**NUMBER:** 21-008-15 REV. B

**GROUP:** Transmission and Transfer Case

Transmission Shift Quality C-Clutch Snap Ring

This bulletin involves removing the transmission, disassembling, and replacing the C-Clutch snap ring.

***Fig. 10 Snap Ring Orientation***

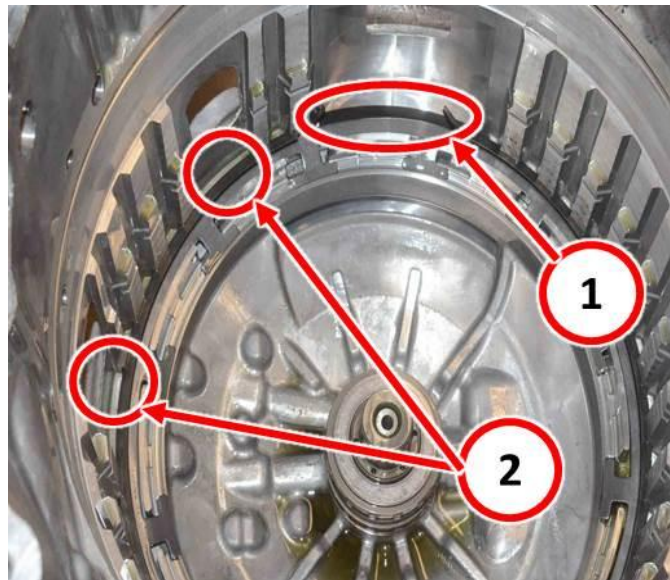
**NOTE: The new C-Clutch snap ring will be installed with the opening in a different position from the original.**

34. Install the new snap ring with the opening rotated 90 degrees counter clockwise from the original snap ring location. See (Fig. 10) and (Fig. 11).

- 1 - Original snap ring opening installation location
  - 2 - New snap ring opening installation location
-
